Summer Shade Solar, LLC

Responses to Siting Board's Second Request for Information

Case No. 2025-00064 Summer Shade Solar, LLC

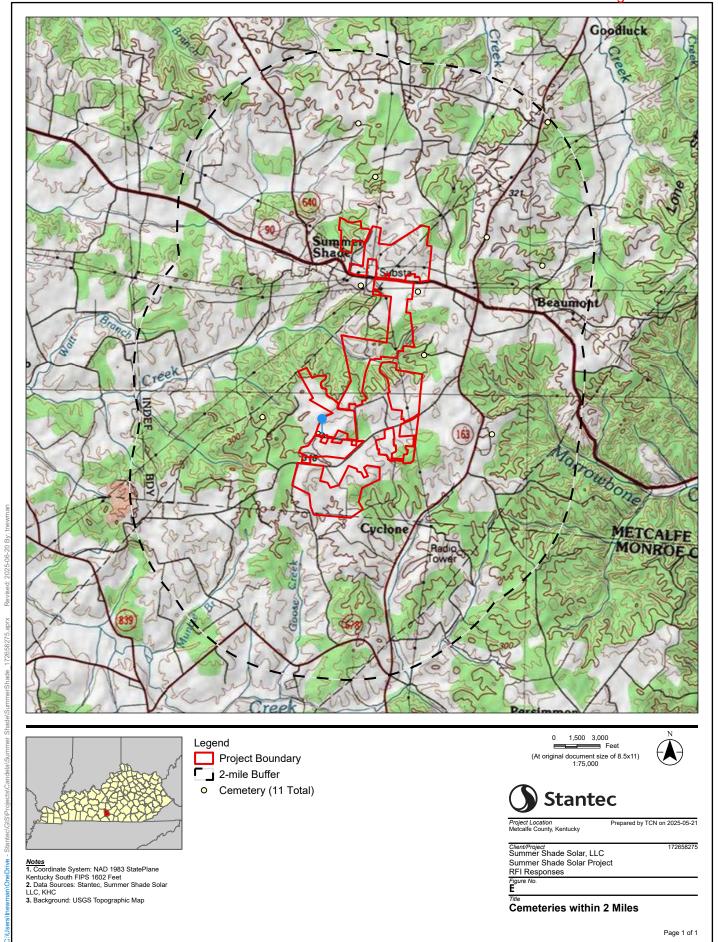
Refer to Summer Shade's response to Staff's First Request First, Item 61. Submit the map

mentioned in the response.

Response: The map mentioned in response to Item 61 of the Staff's First Request of Information

was inserted into the electronic file on the page immediately preceding the response to Item 61. It

is being attached again to this response.

TYPICAL AGRICULTURAL SECURITY FENCE DETAIL - ARRAY

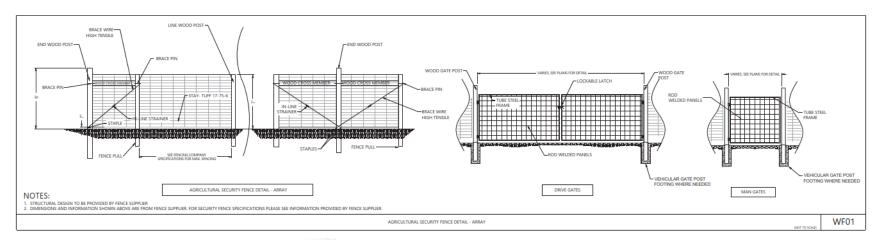
Refer to Summer Shade's response to Staff's First Request, Item 99. Submit the attachment

mentioned in the response.

Response: The attachment mentioned in response to Item 99 of the Staff's First Request of

Information was inserted into the electronic file on the page immediately preceding the response

to Item 99. It is being attached again to this response.

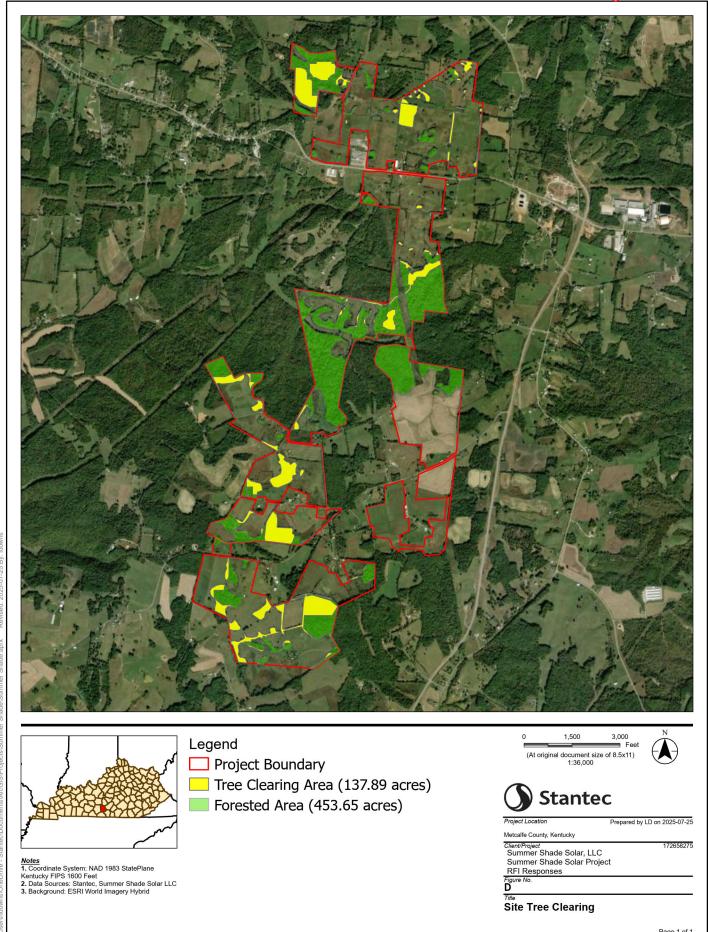
Refer to Summer Shade's Response to Staff's First Request, Item 81 and Stantec Bat Mist

Net Survey. Provide a map showing the boundaries of the 523.08 acres of summer bat habitat

forest, and the proposed 246 acres of vegetative clearing expected during construction.

Response: The current project extents contain approximately 454 acres of forested habitat. The

project design anticipates only clearing approximately 138 acres of forest to support project

development. See the attached map below showing current forested bat habitat on the project site

and the anticipated tree clearing areas.

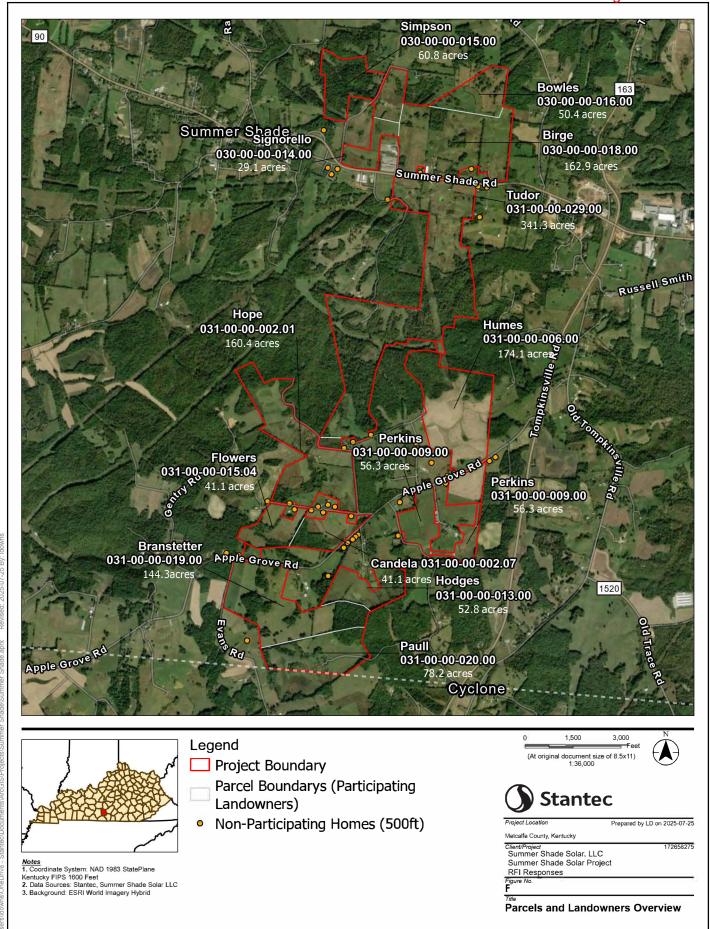
SITING BOARD 2-49:

Provide a parcel map for the proposed site. Include all residences within 500 feet of the

Response: See the attached map below showing participating landowner parcels and adjacent non-

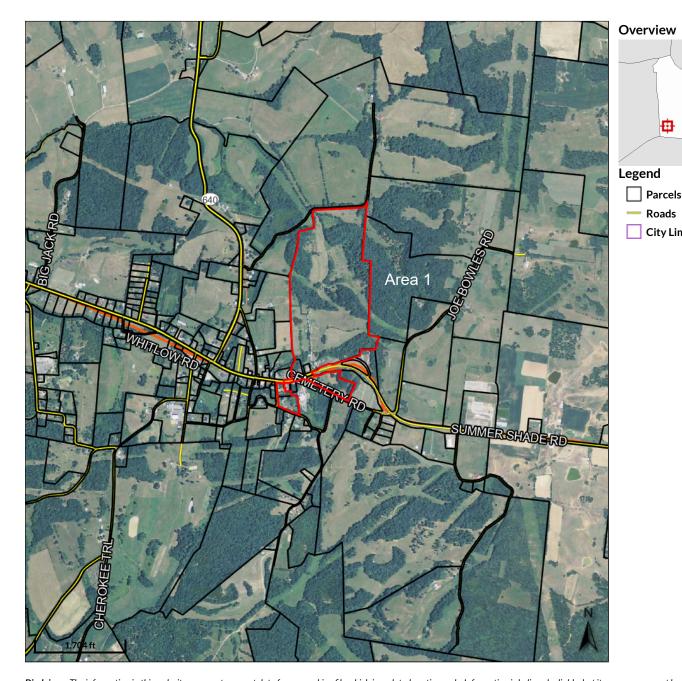
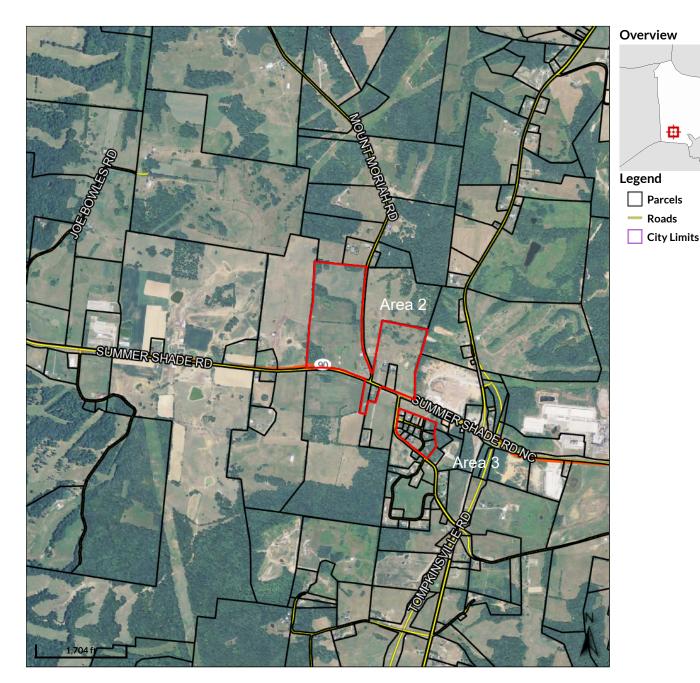
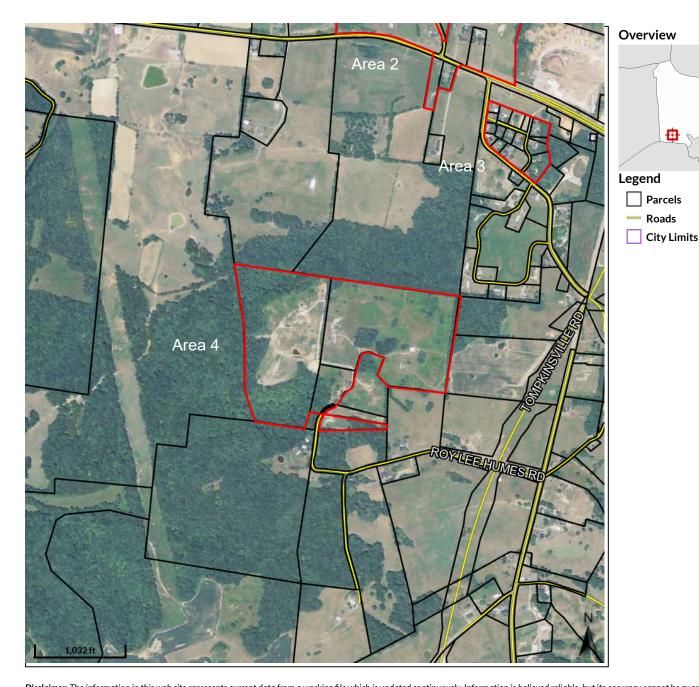
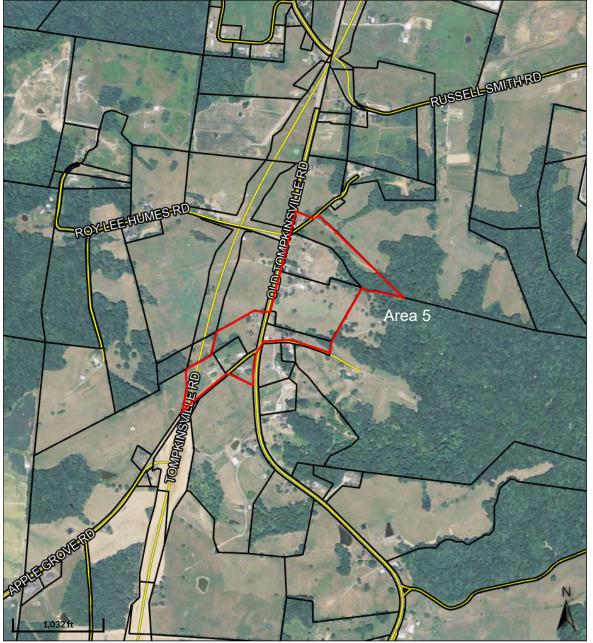
Refer to Summer Shade's Motion for Deviation. Provide a parcel map for each of the six

areas that were discussed in Summer Shade's Motion for Deviation. For each parcel provide the

on the parcel explain the structure's design, historical use, and current condition.

Response: See the attached map and table below for the requested information. Although

historical use for the properties are not know, the table includes the year in which the PVA lists

the year in which the residential structure was estimated to have been built or installed.
